Form 3160-5
(August 2007)

SUNDRY NOTICES AND REPORTS ON WELLS RECEIVED
Do not use this form for proposals to drill or to re-enter an abandoned well. Use form 3160-3 (APD) for such proposals.

5. Lease Serial No. NMLC029339B
6. If Indian, Allottee or Tribe Name
7. If Unit or CA/Agreement, Name and/or No.
8. Well Name and No. ARTESIA PETROLEUM CO. 2-H
9. API Well No. 30-015-04035-00-S1
10. Field and Pool, or Exploratory SQUARE LAKE
11. County or Parish, and State EDDY COUNTY, NM

**Permanent Abandonment of Federal Wells
Conditions of Approval**

COG Operating, LLC
 Artesia Petroleum Co. #002
 1980 FNL 660 FEL
 H-01-17S-30E
 Eddy Co., NM
 30-015-04035

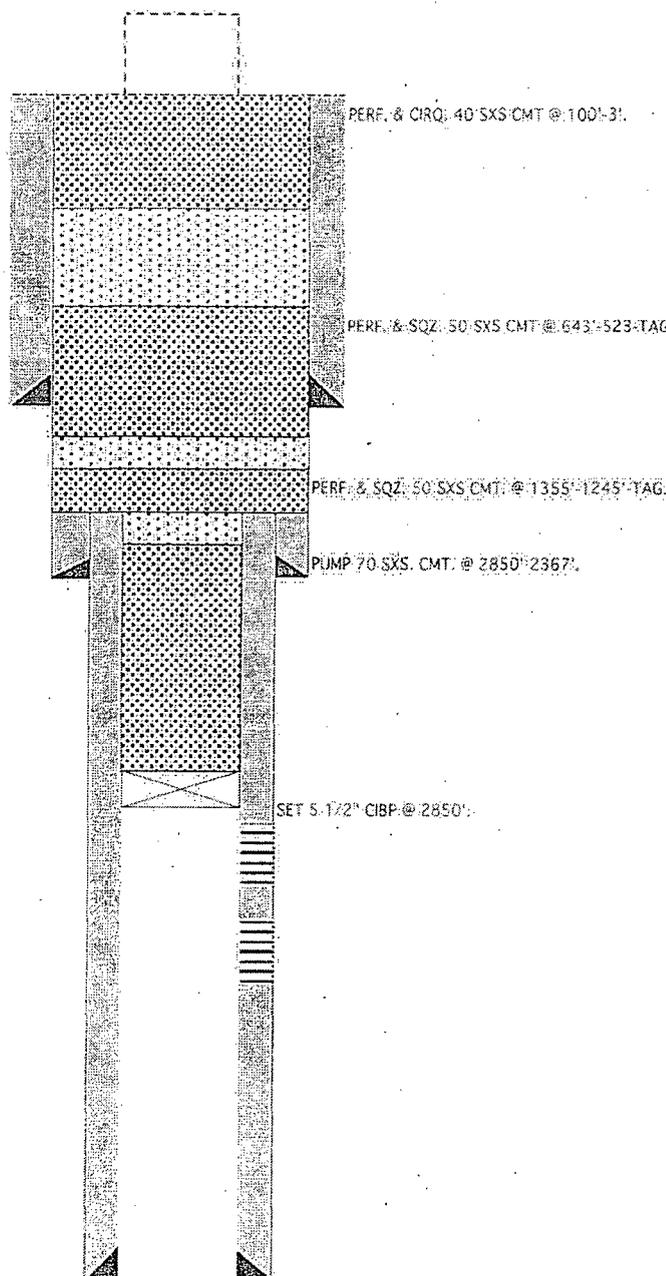
*At cut-off verify cost to surf. all annulus,
Below Ground level Marker Required*
